SUBJECT: DRAFT SITE CHARACTERIZATION ANALYSIS ON BWIP SCR
OPS PLAN NO. 311221E

NUREG-0960

DRAFT SITE CHARACTERIZATION ANALYSIS

THE U.S. DEPARTMENT OF ENERGY
SITE CHARACTERIZATION REPORT
FOR THE
HIGHT WASTE ISOLATION PROJECT

Figure 1. DOE's Conceptual Model of Groundwater Flow.
(After SCR FIGURE 12-10. Schematic Representation of Groundwater Flow Path for Case I. page 12.4-46)

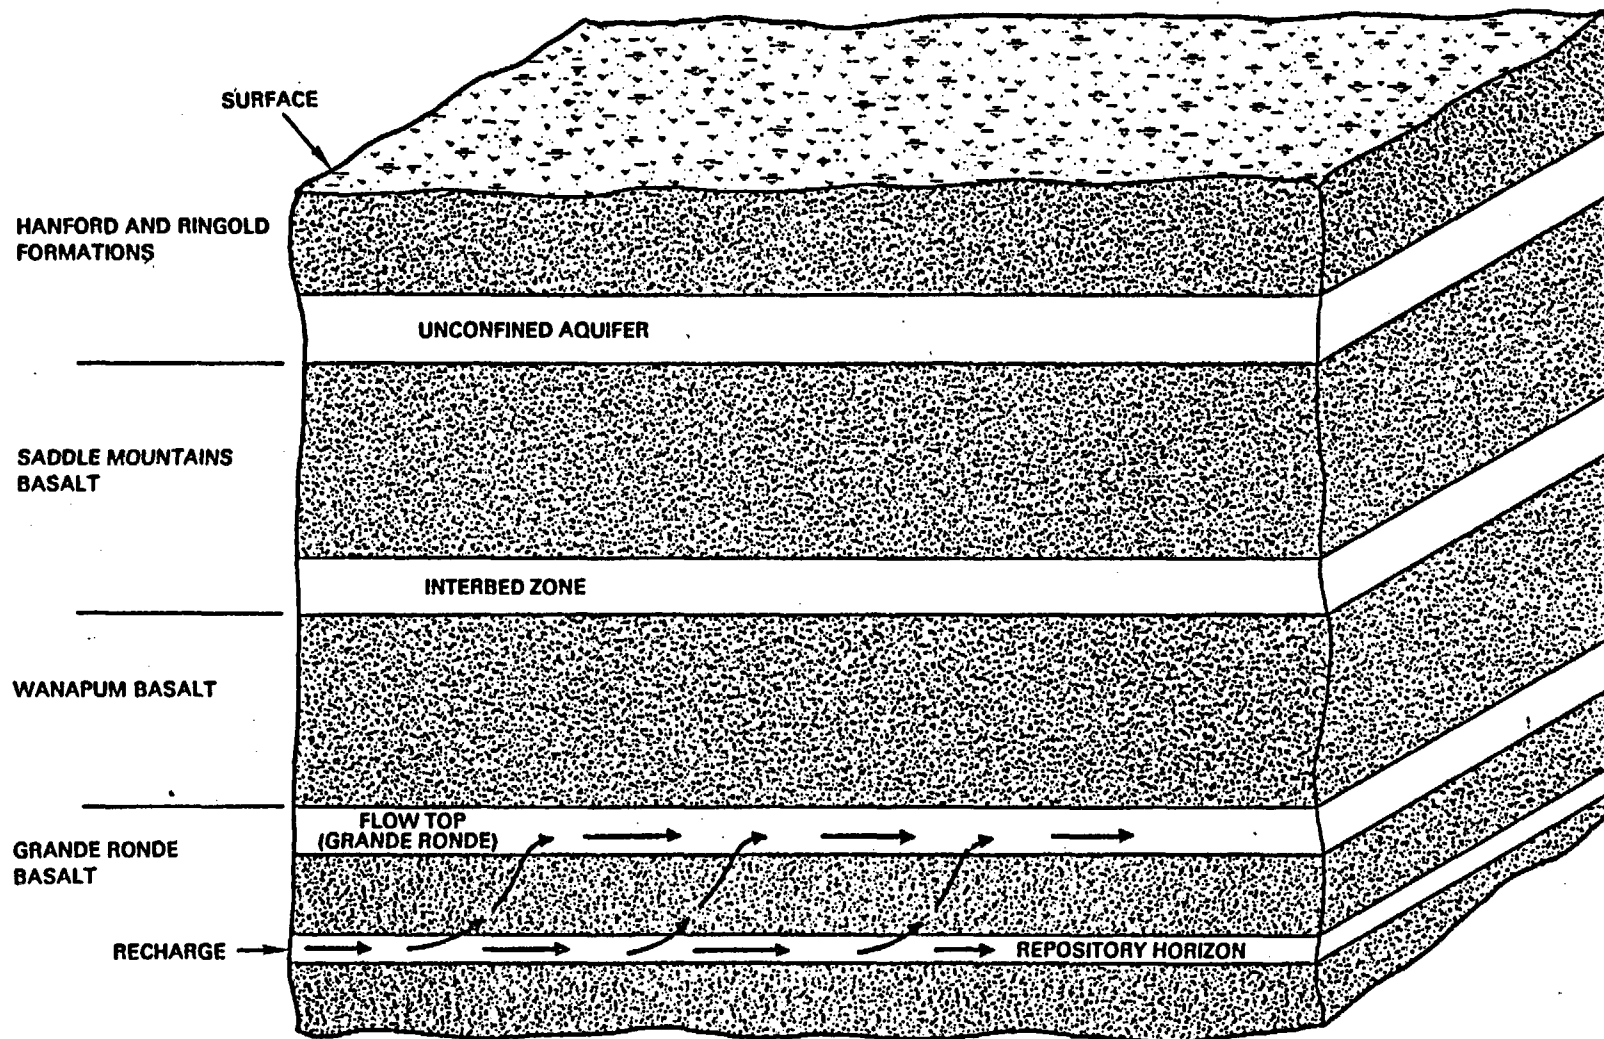
The conceptual groundwater model presented in the SCR is based essentially on a geologic system that consists of areally continuous, layered basalt flows and interbeds of the Columbia River Basalt Group (Figure 1). The main features of this model are that the flow systems are layered and confined, with interbeds and flow tops acting as homogeneous aquifers and low-permeability columnar basalt zones acting as homogeneous confining layers. Horizontal and vertical hydraulic gradients are interpreted to be minimal. While DOE recognizes that vertical leakage potentially occurs across flow interiors, strong assertions are made that little vertical flow occurs between shallow and deep flow systems in undeformed areas. Apparent breaks in key hydrochemical parameters are interpreted by DOE to indicate separation of shallow and deep flow system. While

The areally continuous, layered geometry of basalt flows and interflows, with minimal, homogeneous vertical hydraulic conductivity of each unit and minimal, homogeneous horizontal hydraulic conductivity of flow interiors establishes a very nonconservative base case for travel-time and transport calculations. The conceptual and numerical models presented in the SCR do not account adequately for the effects on groundwater of structural and stratigraphic discontinuities that are known to exist in the Columbia River Basalts (Appendix 2). Figure 2, which is a reproduction of SCR Figure 3-29 (page 3.5-30), illustrates complex,

Figure 3. Interpretive Bedrock Structure Map. (After SCR FIGURE 3-52, p. 3.7-29)

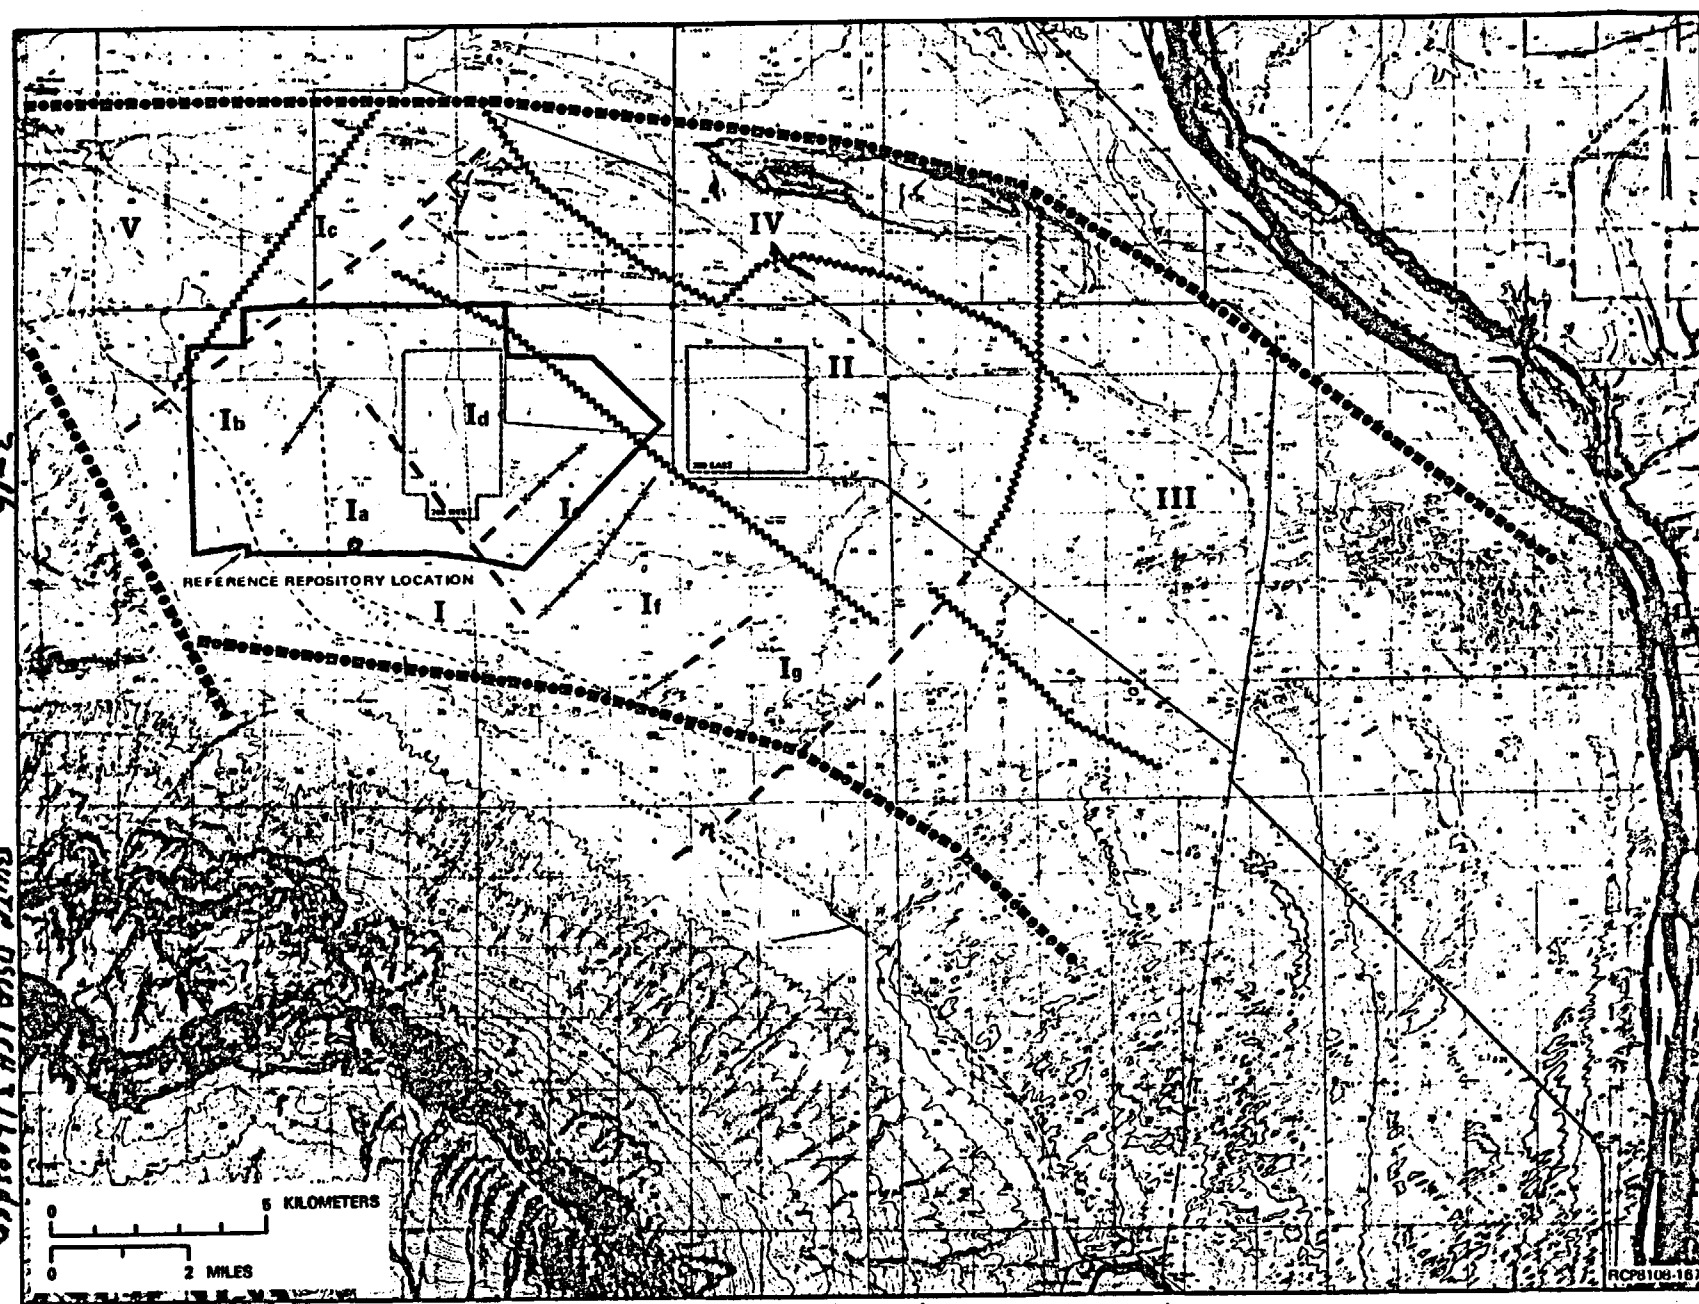
small-scale structural and stratigraphic discontinuities that are spaced meters to tens of meters apart in the Umtanum Flow at the Emerson Nipple Section. Figure 3, a reproduction of SCR Figure 3-52 (page 3.7-29), shows the areal distribution of aeromagnetic anomalies which are interpreted by the BWIP staff as expressions of significant structural features in the subsurface. Many of these features correlate exactly with the trace of major structural features; other features are uncharacterized to date. Irregularities in the distribution of basalts illustrated in the "Top-of-Basalt Contour Map" (SCR Figure 3-51) may well be related to significant stratigraphic discontinuities. Structural discontinuities in the Pasco Basin exist at a variety of scales, from extensive zones of major structural influence (e.g., faulting and fracturing along the Gable Mountain-Umtanum Ridge anticline), through more discrete zones of offset (e.g., the "Nancy Linear"), to small-scale (mm to 1m) tectonic breccias, radiating fans, and cooling joints, which may be spaced meters to tens of meters apart. Stratigraphic discontinuities apparently range in scale from major pinch-outs of basalt flows and sedimentary interbeds to local thickening and thinning of flow-top breccias. The variety and ubiquity of structural and stratigraphic discontinuities apparent in Figure 2 contradict the simplicity of structure and stratigraphy shown in Figure 1, which represents the DOE's conceptual and numerical models.

- (3) An areally discontinuous, layered system bounded by high permeability structures. In this conceptual model, the layered basalt system is divided into a series of discrete blocks as suggested by SCR Figure 3-52 (page 3.7-29). The blocks are bounded by vertically disruptive features of high permeability (e.g., fault zones or tectonic breccias) which provide a direct means of recharge and discharge to and from deep aquifers. On the scale of the zone between the RRL and the accessible environment, this is a noncontinuum model for which the porous-flow-equivalent numerical modeling used in the SCR could yield erroneous and nonconservative flow paths, travel times, and radionuclide fluxes.

FIGURE 1: TECHNICAL PROGRAM CONTROL: TEST PLANS AND PROCEDURES (ILLUSTRATIVE)

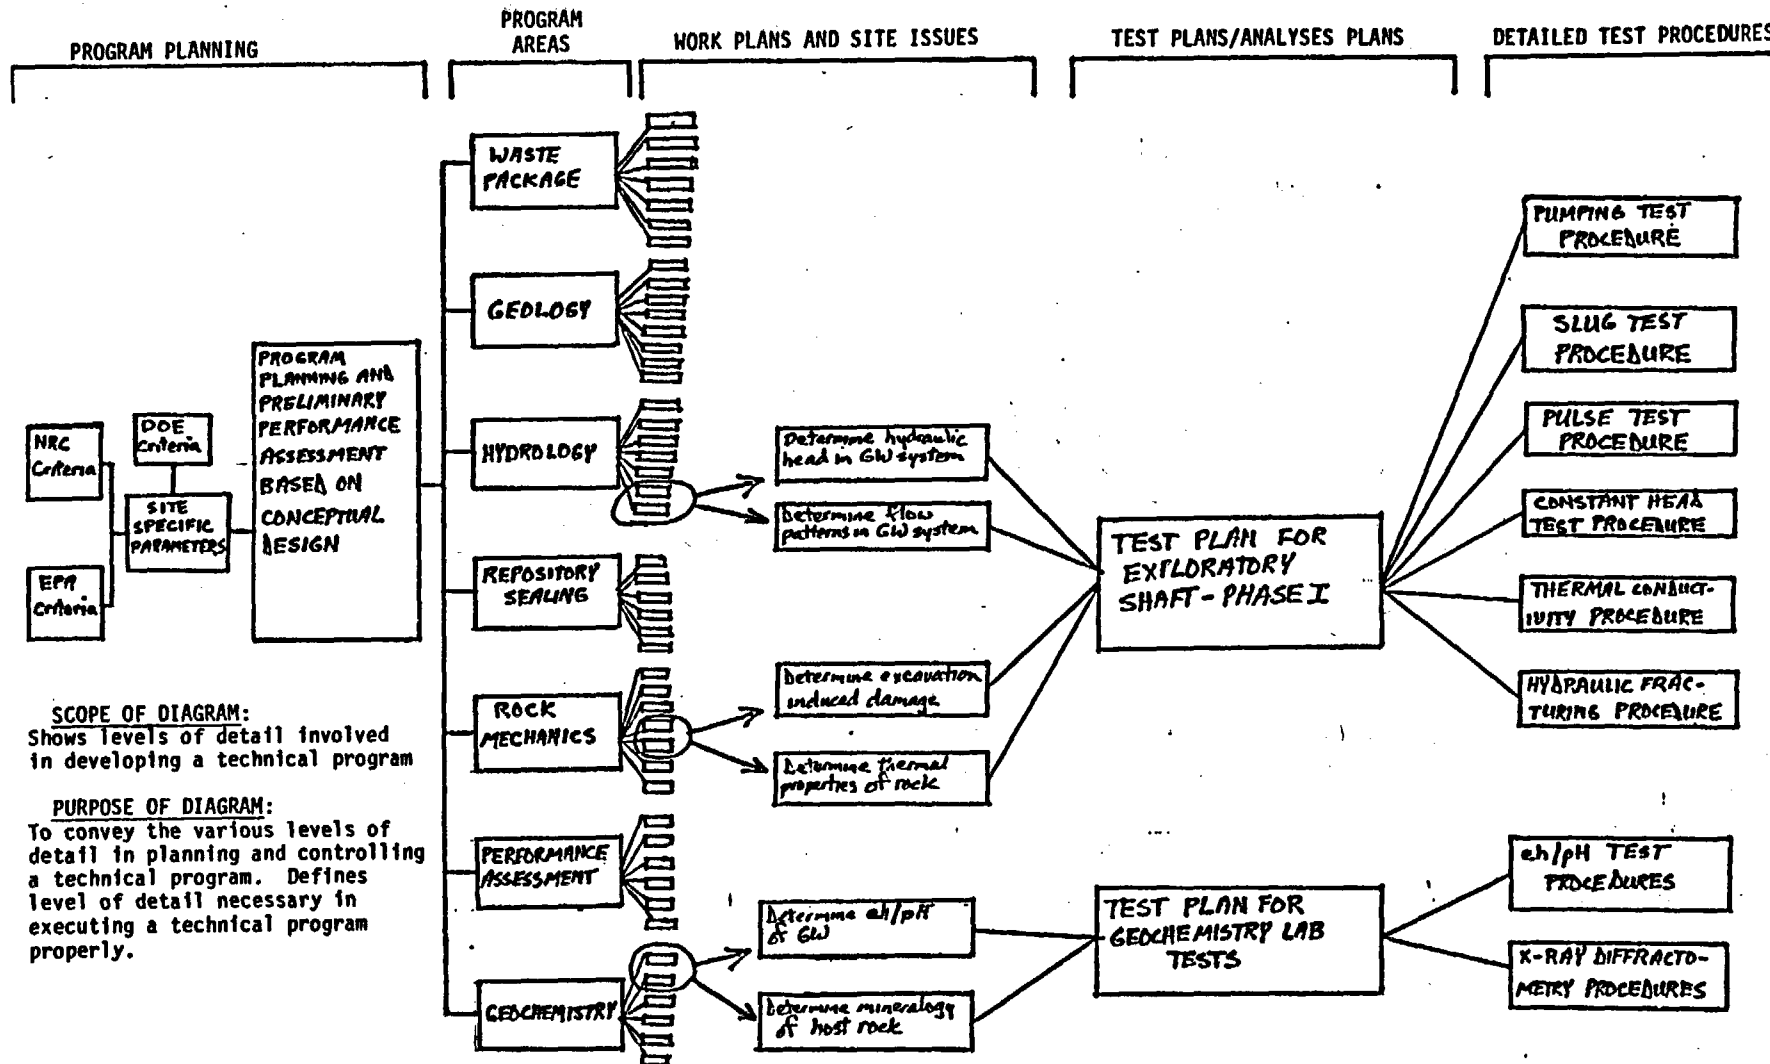
The SCR does not present adequate details regarding implementation of site characterization plans. A complex technical program needs to be based on a systematic approach to planning and controlling the program. The plans need to go from the general to the specific. Quality assurance needs to be applied at all levels. Figure 1 illustrates such an approach.

As shown in Figure 1, site characterization must start by considering EPA and NRC criteria. After a specific site is selected, specific issues are identified, based on these criteria and evaluation of repository performance.

FIGURE 2 : TEST METHOD DEVELOPMENT (ILLUSTRATIVE)

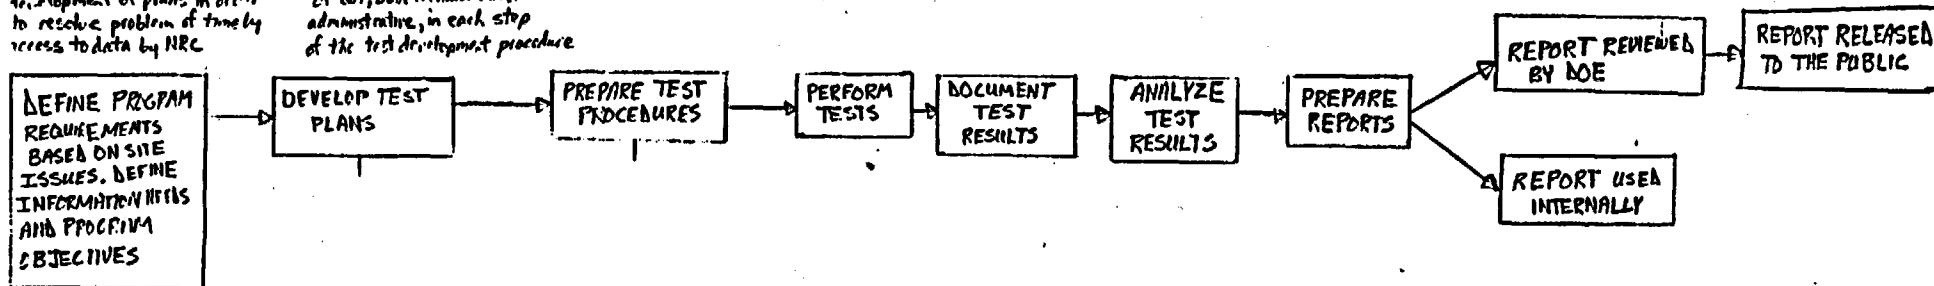
The development of these test plans and test methods is an important element in providing quality assurance for site characterization data. Figure 2 illustrates the development and chronology of events in planning a testing program. This also shows the involvement of QA throughout the entire procedure.
